**Louisville Metro Council City Agency Request**  
**Neighborhood Development Fund (NDF)**  
 ■ **Capital Infrastructure Fund (CIF)**  
**Municipal Aid Program (MAP)**  
**Paving Fund (PAV)**

**Description of program/project including public purpose, additional funding sources, location of project/program and any external grantee(s):**  
 Parking lane shoulder stripe paint and traffic count for Baxter Ave between Winter/Grinstead and Castlewood.

**Department/Project:**  
Public Works/ Baxter Ave parking lane shoulder stripe paint and traffic count

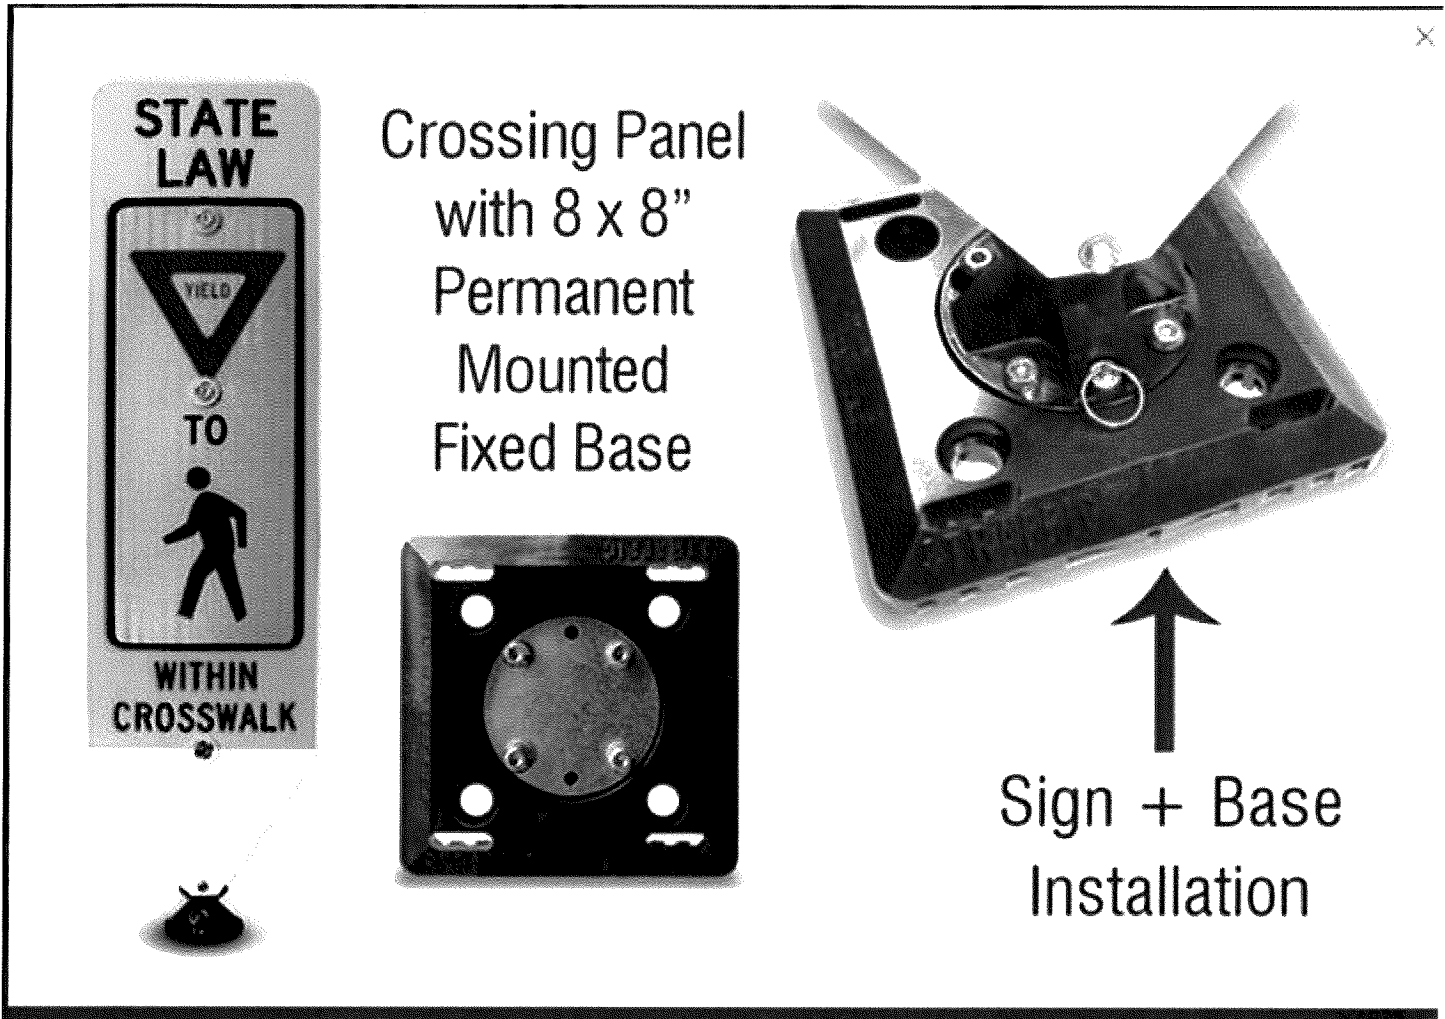
For the crossings at Goddard and Lucia, we would recommend finding a way to construct permanent curb extensions to shorten the crosswalks. Painted extensions usually aren't very effective and delineators have a tendency to detract from the actual pedestrian and can be a maintenance issue. A permanent curb extension can also allow for the installation of the ped crossing signs to be installed closer to the road, increasing their visibility. We did something similar on Preston Street downtown at UofL back in 2015/2016. It might be possible to coordinate with the sidewalk ramp updates on the paving job to potentially add these extensions. Following next year's resurfacing project, we are planning to enhance these two crossings with yield bars and corresponding signage.

A couple of weeks ago I quickly drafted a sketch plan set for this possibility. Attached is what I came up with on a very quick review. Keep in mind they are not to scale and do not necessarily correspond to existing No Stopping signs, fire hydrants, Tarc stops, etc. As this work would require a more detailed review and traffic control, I would recommend we go through the Permit process to ensure we have documentation of the scope and desired final product.

Thanks Jason, I like the enhanced taper & parking restrictions at the Lucia uncontrolled crosswalk. With the longer taper, could we create a 4' gore in the centerline for the installation of Yield to Ped panels at the Goddard crosswalk and Lucia crosswalk, with yield bars and advanced warning? We may also be proposing paint and post curb extensions for the Goddard crossing, send you a plan soon.
